7.0 Instrumentation and Control Systems

7.1 Introduction

The information in this section of the reference ABWR DCD, including all subsections and tables, and figures, is incorporated by reference with the following departures and supplements.

Figure 7.1-1 ~~SSLC Self-Test System~~ Diagnosis

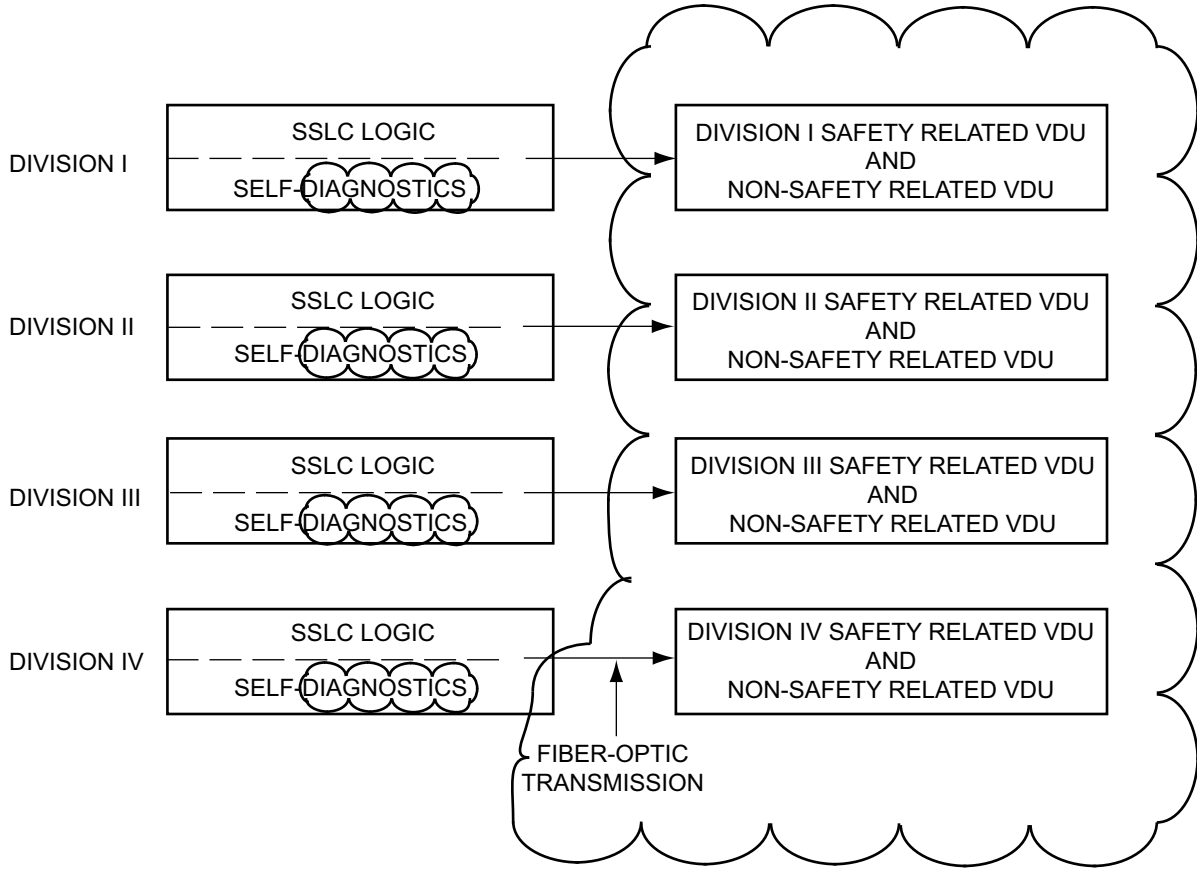
STD DEP T1 3.4-1 (Figure 7.1-1, 7.1-2)

STD DEP T1 3.4-1

Each individual safety-related system utilizes redundant channels of safety-related instruments for initiating safety action. The automatic decision making and trip logic functions associated with the safety action of several safety-related nuclear steam supply systems (NSSS) are accomplished by ~~a four-division correlated and separated protection logic complex called the safety system logic and control (SSLC)~~. The SSLC includes multiple redundant divisions, which are separated from each other. The SSLC has four redundant divisions of sensors. Each division of sensors has a corresponding division that determines the trip status of the safety functions relative to the safety function setpoint. The SSLC has four redundant divisions for all actuation functions except for the engineered safety features. The engineered safety features have three divisions, corresponding to the maximum redundancy of the engineered safety features actuated components. Some engineered safety features functions are less than three-fold redundant and are assigned to the appropriate set of redundant divisions. The SSLC multi-divisional complex includes divisionally separate control room and other panels which house the SSLC equipment for controlling the various safety function actuation devices. The SSLC receives input signals from the redundant

~~Divisional separation is also applied to the essential multiplexing system (EMS), which provides data highways for the sensor input to the logic units and for the logic output to the system actuators (actuated devices such as pump motors and motor operated valves). Systems which utilize the SSLC are include: (1) Reactor Protection (trip) System; (2) High Pressure Core Flooder System; (3) Residual Heat Removal System; (4) Automatic Depressurization System; (5) Leak Detection and Isolation System; (6) Suppression Pool Temperature Monitoring System; and (7) Reactor Core Isolation Cooling System. The equipment arrangement for these systems and other supporting systems is shown in Figure 7.1-2.~~

The RPS RTIS and ESFELCS Systems can be tested during reactor operation ~~by six separate tests.~~ The first five tests are primarily manual tests and, although each individually is a partial test, combined with the sixth test they constitute a complete system test. The sixth test is ~~the self~~ test of the safety system logic and control which ~~automatically~~ tests the complete system excluding sensors and actuators.
